## **LOT 41 CARDUP SIDING ROAD, CARDUP STORMWATER MANAGEMENT PLAN - ADDENDUM**

This addendum is to support the current Application for Development Approval which includes seeking approval to modify to the overall drainage system on Lot 41 Cardup Siding Road.

PROJECT:  
LOT 41 CARDUP SIDING ROAD  
CARDUP  
DRAWING TITLE:  
STORMWATER DRAINAGE LAYOUT

DRAWN D.RULLO	WAPC No.
DESIGNED O.SILUKA	SCALE: A1 AS SHOWN
PROJECT MANAGER O.SILUKA	DATUM AHD
CO-ORDS PC694	REVISION 2
JDSi PROJECT No. JDS13728.2	DRAWING No. C350

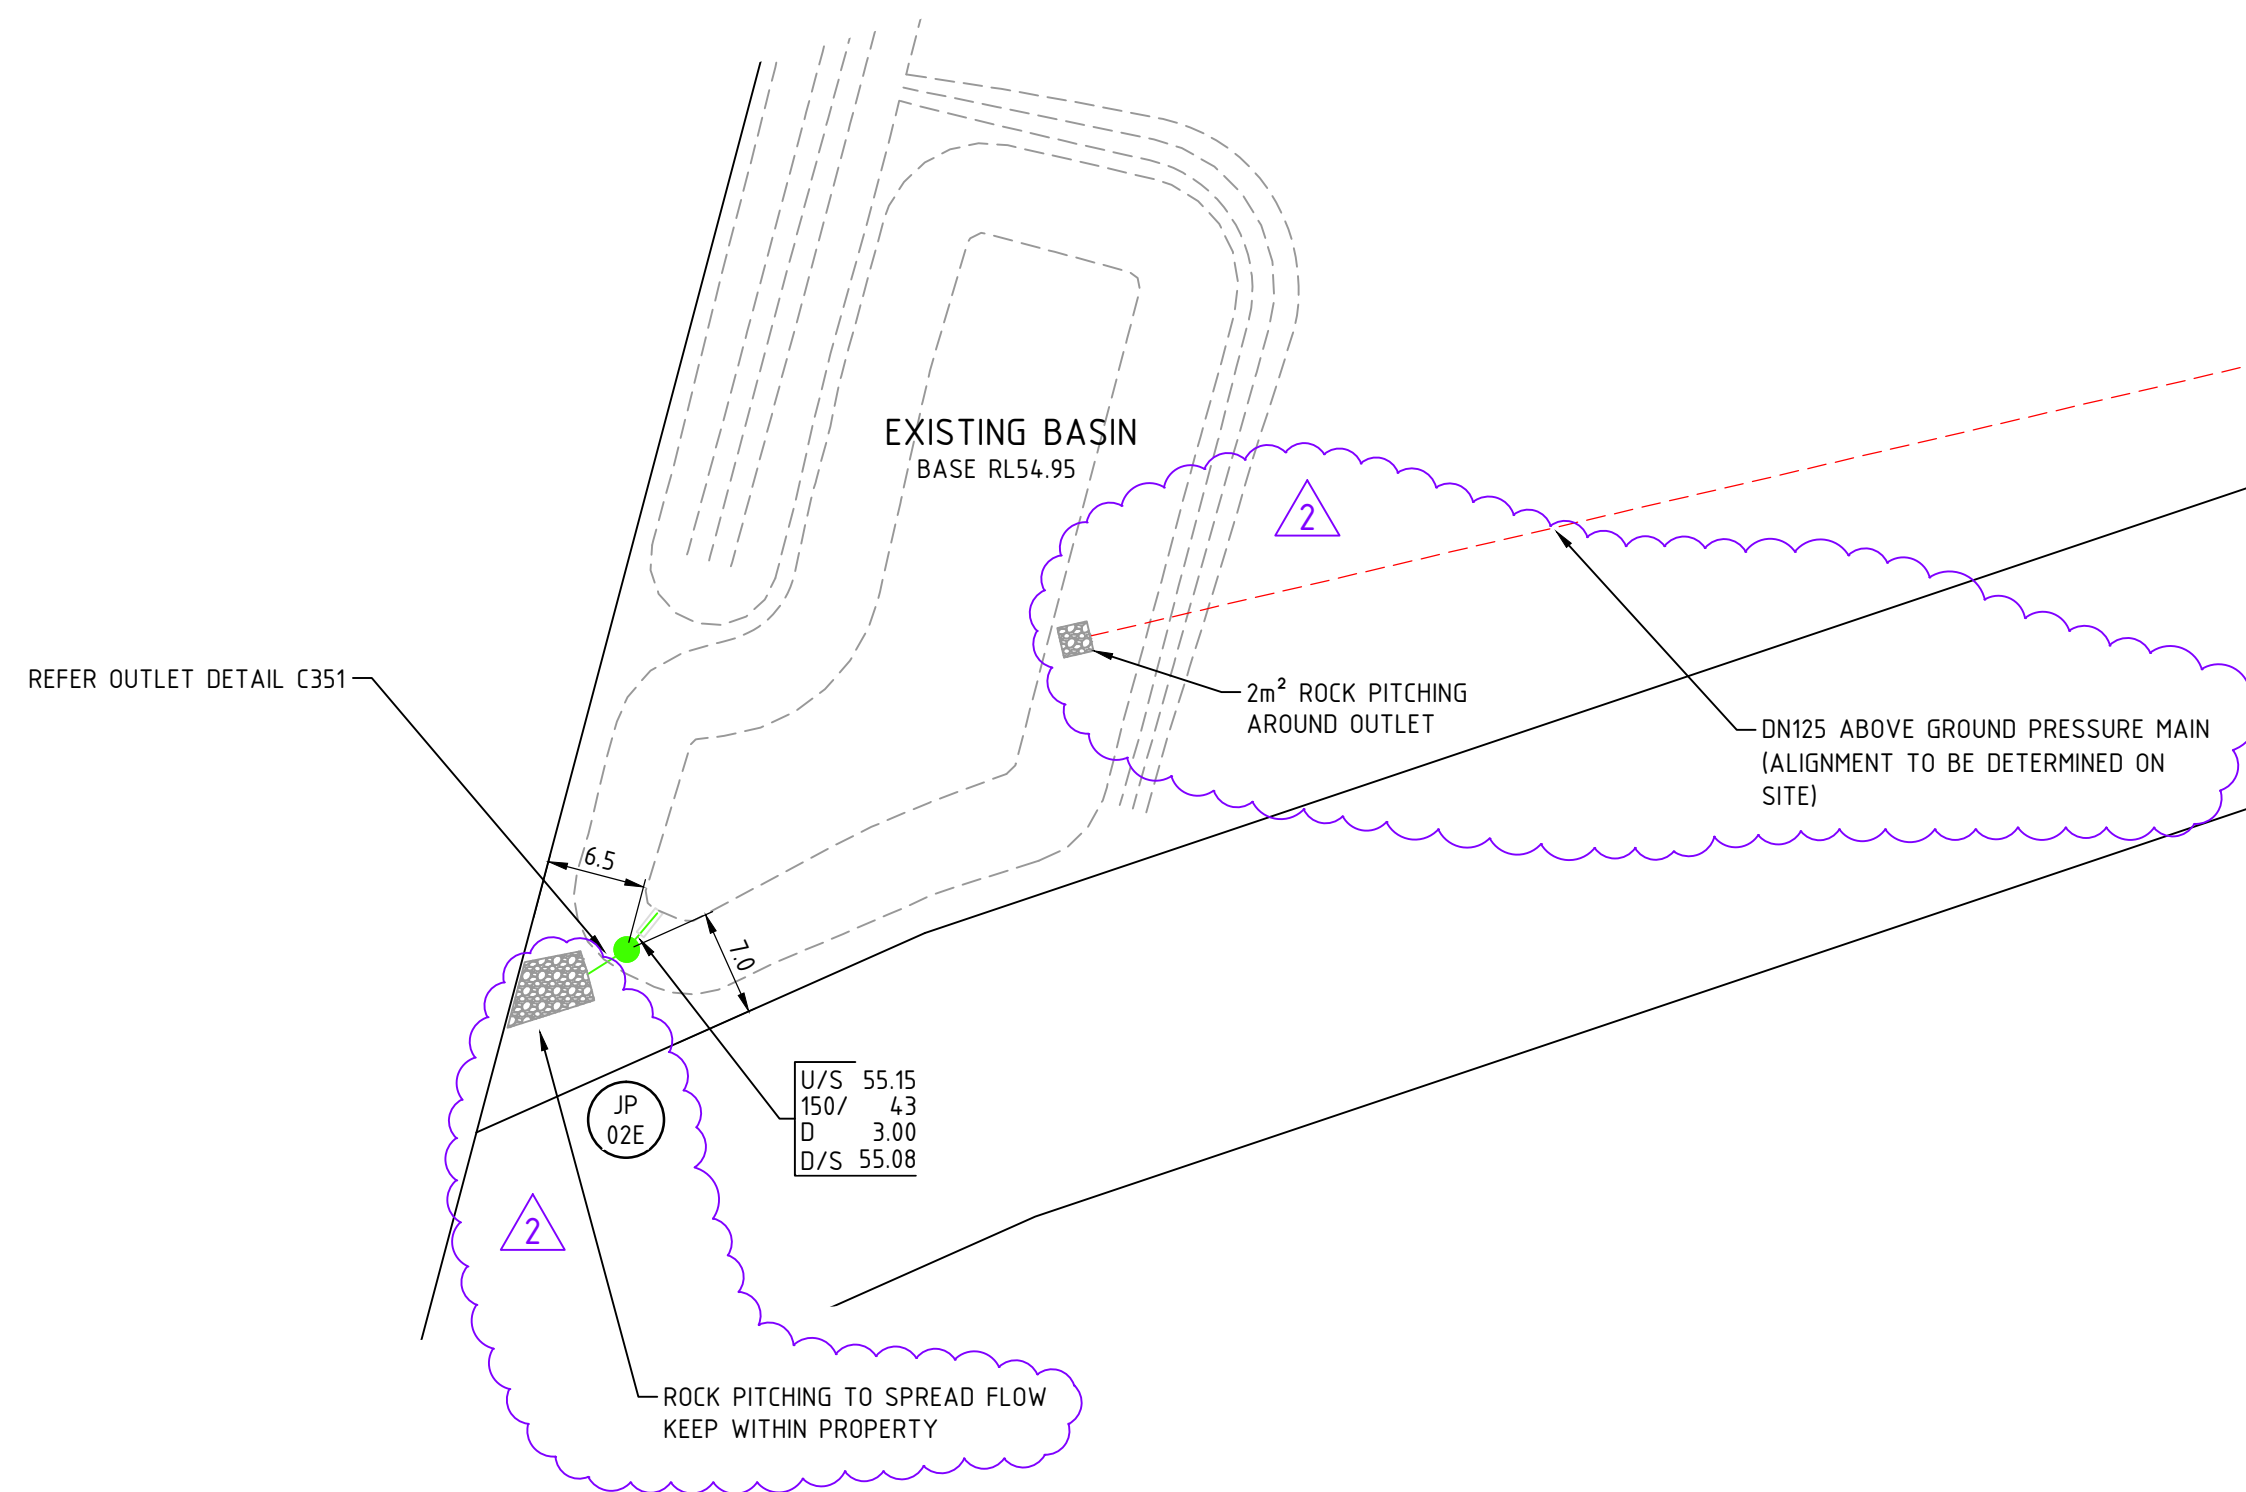
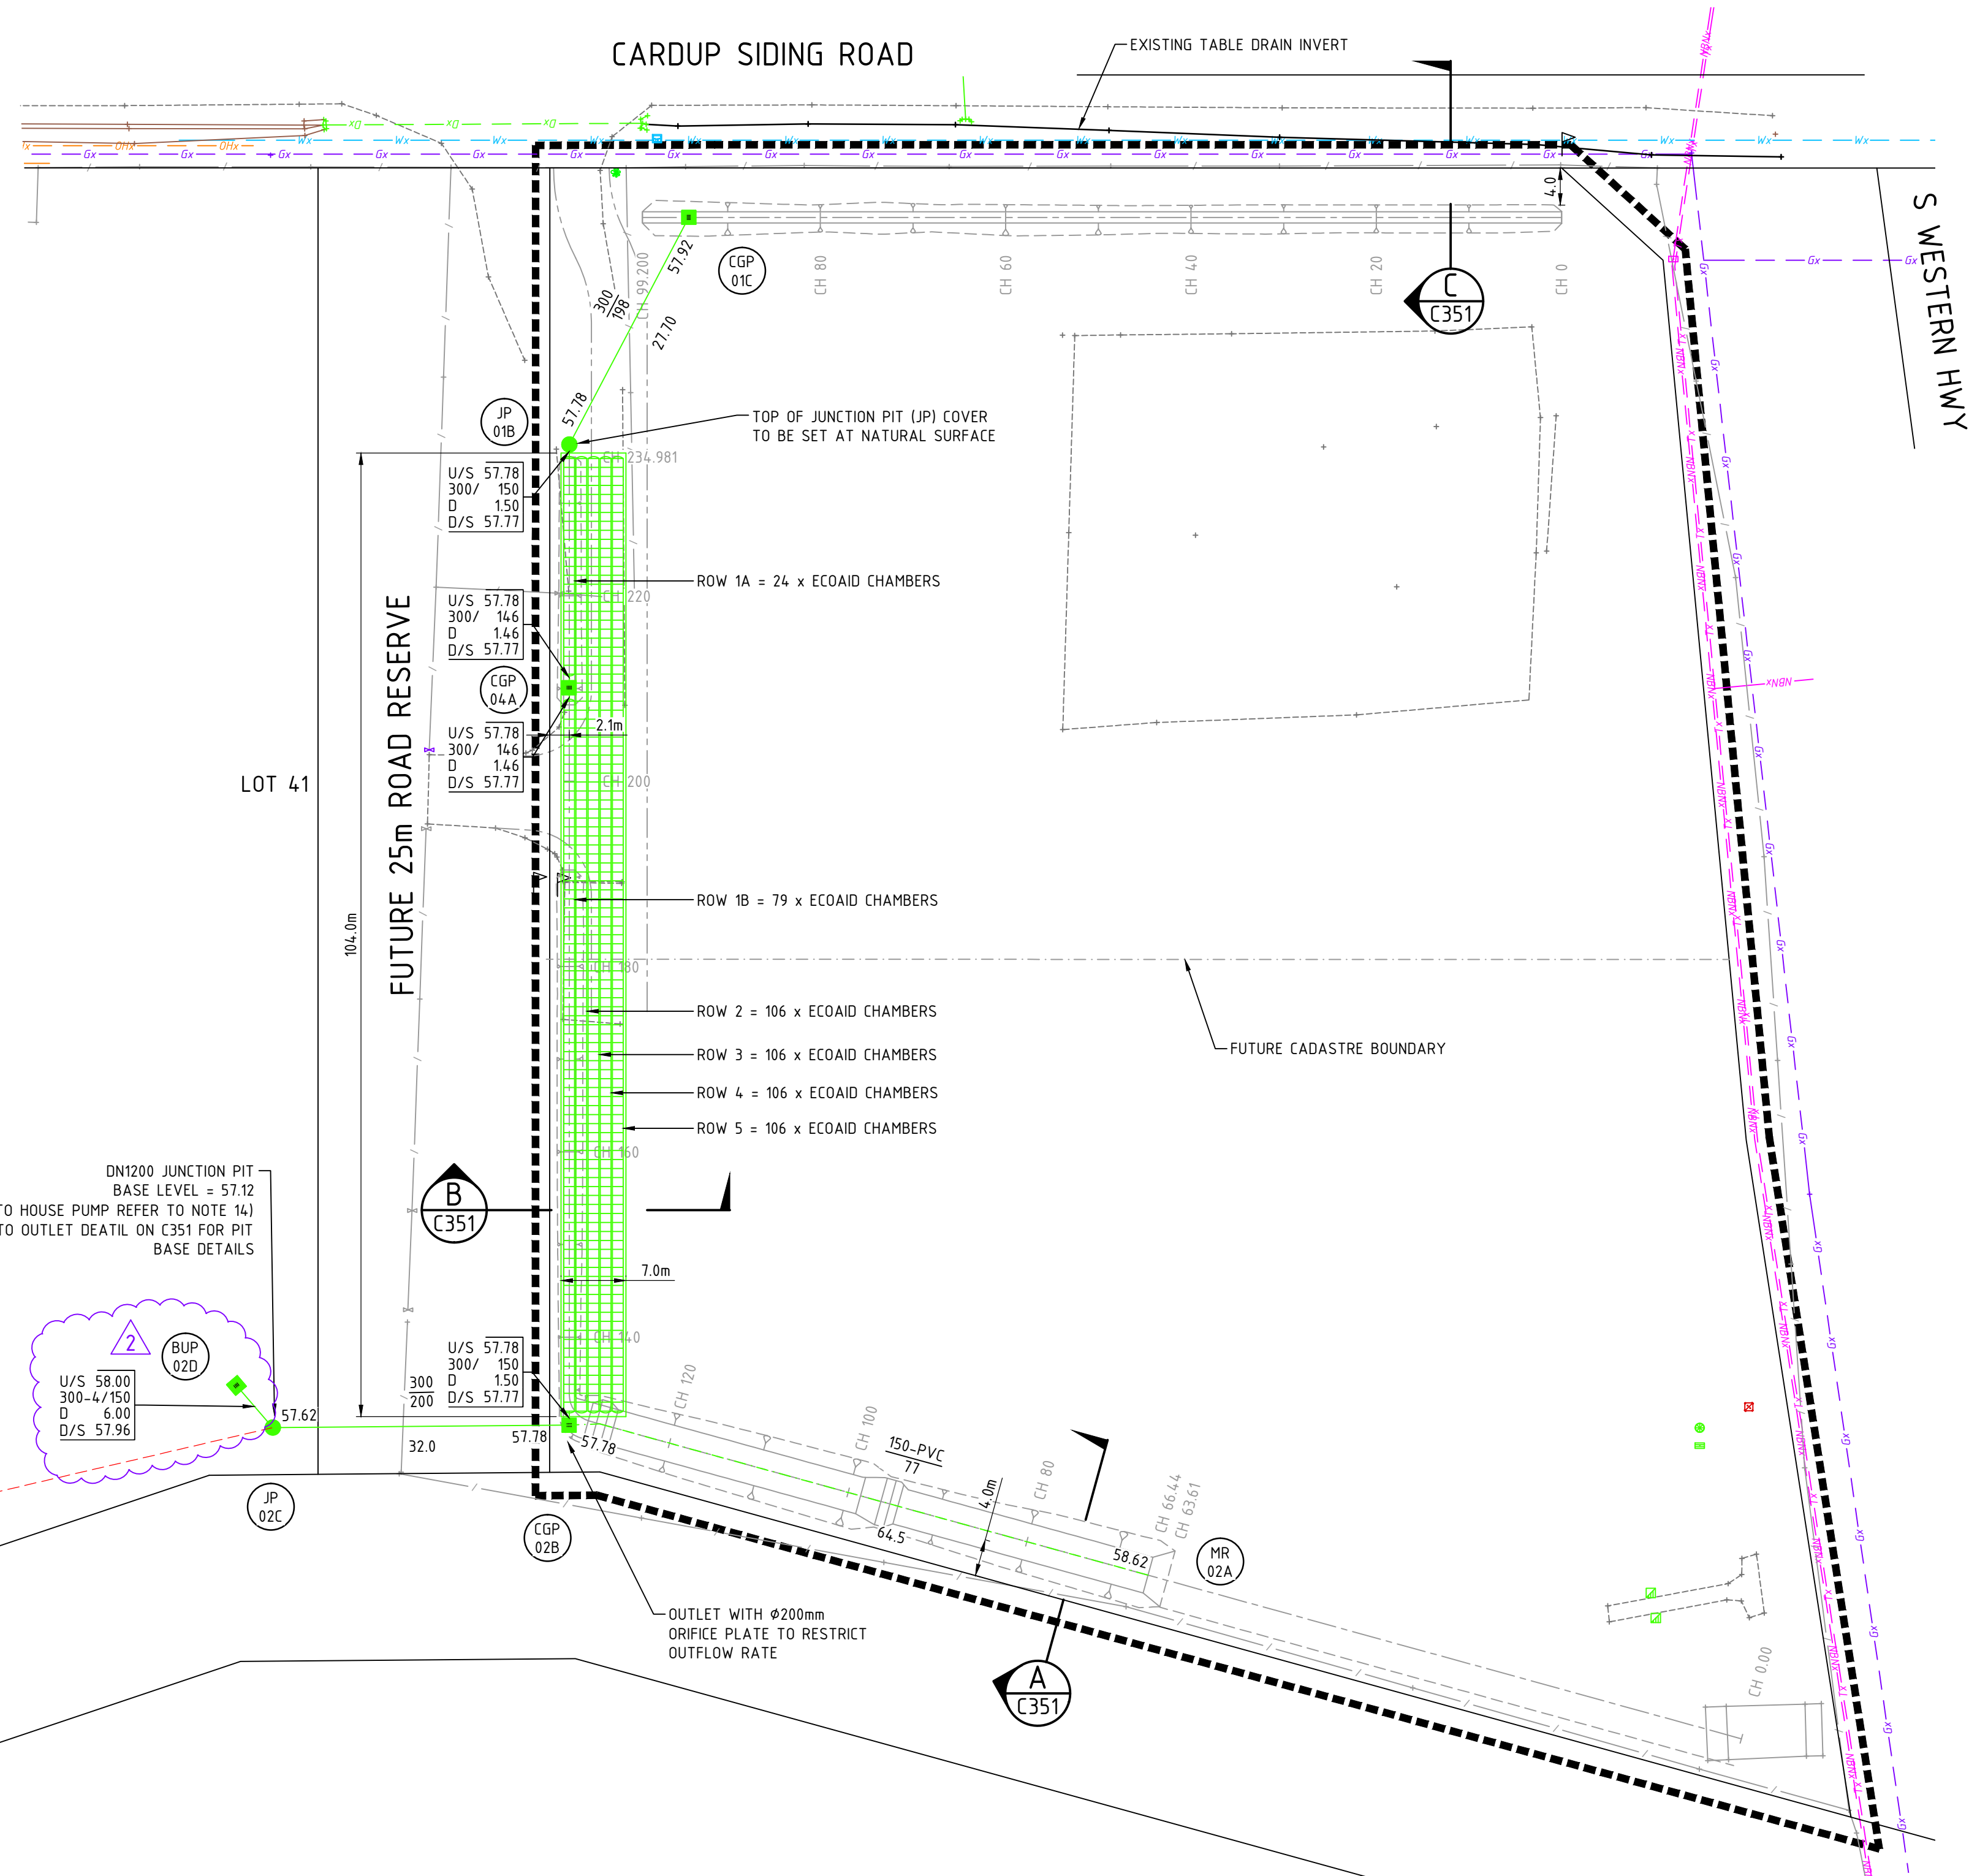
The low infiltration rate was also likely to place similar limitations on the performance of the underground storage tanks. The solution developed with Officers was the provision of two pumps, one to pump water from the underground storage to the basin and one to pump water from the basin (Refer attached **Drawing C350 Rev B**). Both pumps were low flow with the intent being to gradually empty both storages at a controlled rate with discharge less than pre-development flows.

The current design is shown on attached **Drawing C350 Rev 3**.

The design retains the original concept of all drainage in the eastern portion of the site, including the proposed new warehouse development, being directed to the bio retention swales and underground storage units then pumped to the drainage basin to enable gradual emptying.

Drainage of the western portion of the site remains unchanged apart from modification to the discharge from the basin. It is now proposed to gradually discharge stormwater by pumping into a 150mm diameter perforated pipe which extends 150m along the western boundary of Lot 41. The pipe will be wrapped in a filter media (Flitersock) and be contained within loose limestone spalls covering the pipe. This will ensure stormwater slowly discharges along the length of the pipe in a controlled manner with no potential to cause scour.

The basin discharge pump will have a maximum pumping rate of 23 litres per second which is roughly 8% of the calculated pre-development flow. Discharging over the 150m length also mimics the pre-development sheet flow conditions rather than concentrating flow at a single discharge point.
